### **Proposal for Supplement 16 to the 02 series of amendments to Regulation No. 3 (Retro-reflecting devices)**

#### **Submitted by the expert from the International Automotive Lighting and Light Signalling Expert Group (GTB)\***

The text reproduced below was prepared by the expert from GTB to clarify the testing procedures. The modifications to the existing text of the Regulation are marked in bold for new or strikethrough for deleted characters.

"Figure 1  
 (Marking for single lamps)

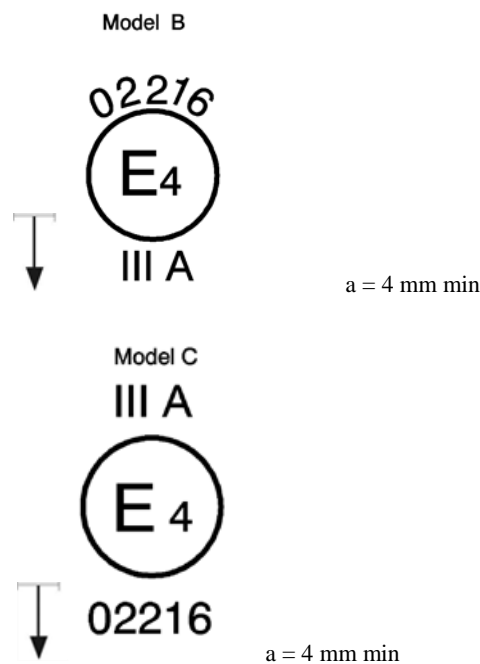
Annex 3, figure 1., amend to read (addition of downward pointing arrow):

**The vertical arrow starting from a horizontal segment and directed downwards indicates a permissible mounting height of equal to or less than 750 mm from the ground for this device and can be placed either above or below the circle surrounding the letter "E" or at its side, close to the group of symbols indicating the class or the digits constituting the approval number.**
